## NAVION

**47-11-1 Navion** (Was Mandatory Note 1 of AD-782-3.) Applies Only to Serial Numbers NAV-4-2 to NAV-4-550, Inclusive. To be accomplished immediately.

FIGURE 1

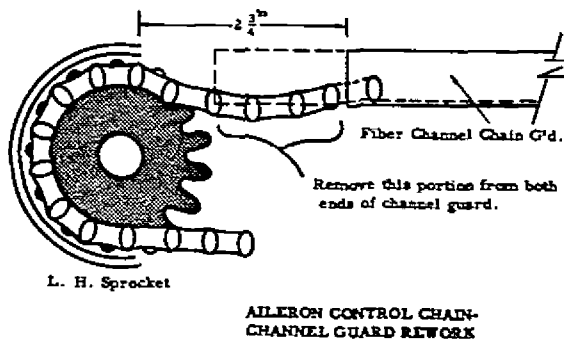
In order to eliminate the possibility of the aileron control chain jamming, each end of the fiber channel chain guard should be reworked as shown in Figure 1. The chain and guard are on the control column.

FIGURE 2

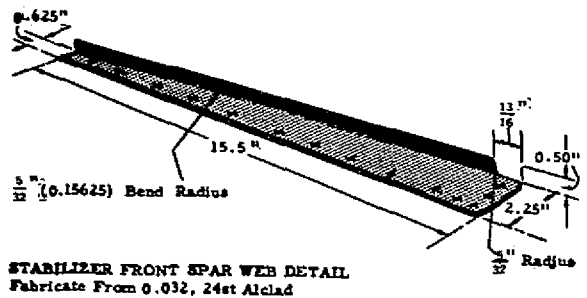
Inspect as soon as practical, but not later than February 1, 1953, and at 100-hour inter-

vals thereafter the area in the vicinity of the stabilizer fuselage attachment for cracks. Particular attention should be given to the stabilizer spar web (gusset) immediately outboard of the root rib and the fuselage attaching fitting. If cracks are found in the fuselage fitting, P/N 143-31004-13, the entire part should be replaced. Cracks in the root rib may be repaired in accordance with CAM No. 18. Cracks in the spar web (gusset) require the replacement of the gusset with a new part made in accordance with Figure 2.

Periodic inspections of stabilizer spar web only may be discontinued after installation of new gussets.
